To: Nick Sugar, City Planner and Amanda Krickovich, Community Development, City of Hudson
From: Olivia Hopkins, AIA | Historic Architecture, Perspectus
Date: March 7, 2023
Re: 136 Hudson Street
CC: Lauren Pinney Burge, AIA, Principal & Alice Sloan, Assoc. AIA, APT-RP | Historic Architecture, Perspectus

SUBJECT PROPERTY: 136 Hudson Street

Image 1: 1950. Courtesy of The City of Hudson.

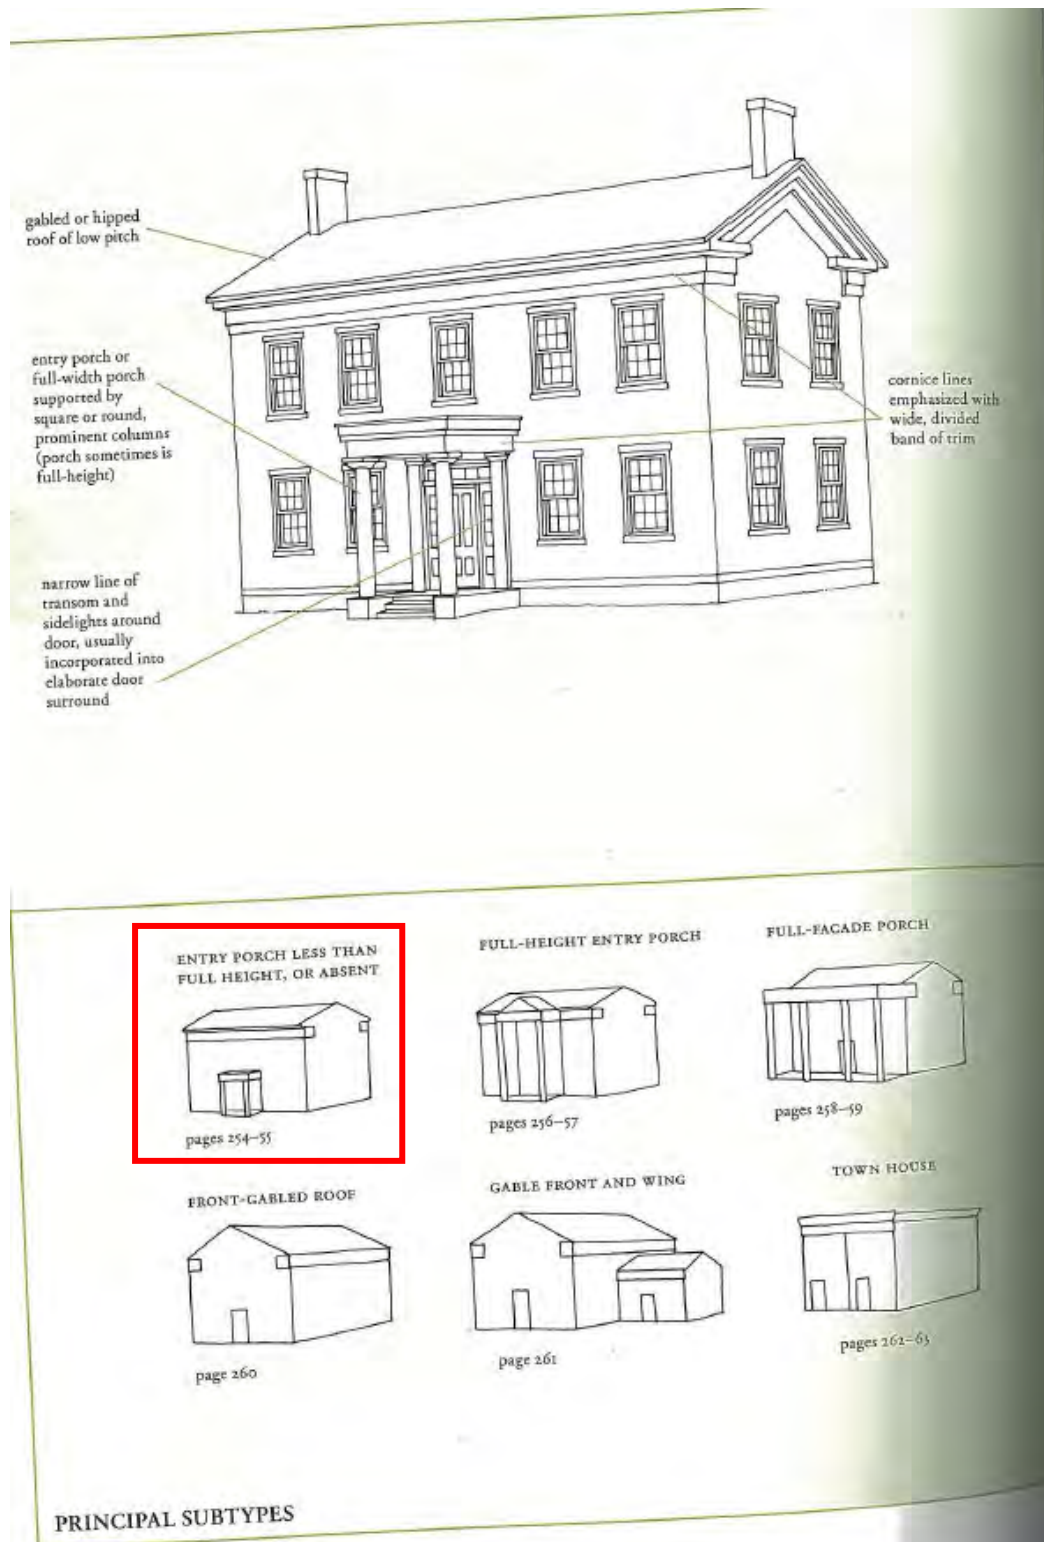
- b. **Change #2:** The canopy (front porch) design should be modified to resemble one of two forms to comply with the Standards:
The first option is to recreate the gable-fronted porch visible in the 1950 photograph included in this report, which meets Standard #6 (replacement of missing features shall be substantiated by documentary, physical, or pictorial evidence). This design is appropriate as it is a previously documented feature and gained historical significance due to the Period of Significance for the district ending in 1963.
The second option is to modify the canopy (front porch) to a configuration typical of houses reflecting the Greek Revival style, as the house is significant under Criteria C as an example of this style. The detailing of the front porch as proposed is appropriate, but the height is not. Note that Ohio is part of the region where a common front porch height is either less than full height or absent (see the images from the McAlester book included in this report). The existing shallow overhang should be removed, and the new canopy (front porch) should align with this part of the façade, just above the door head trim. The low-slope (flat) roof, square Doric columns, and frieze board may remain part of the design.

6. According to the 1950 historic photograph and the 1989 NRN photograph, the original c. 1854 house has experienced changes to its exterior. Between 1950 and 1989, the front porch (which consisted of a gable facing canopy/overhang that interfaced with the frieze) was removed, the shutters were removed, and the door color lightened. Between 1989 and 2024, shutters were added, and the window frame color lightened.
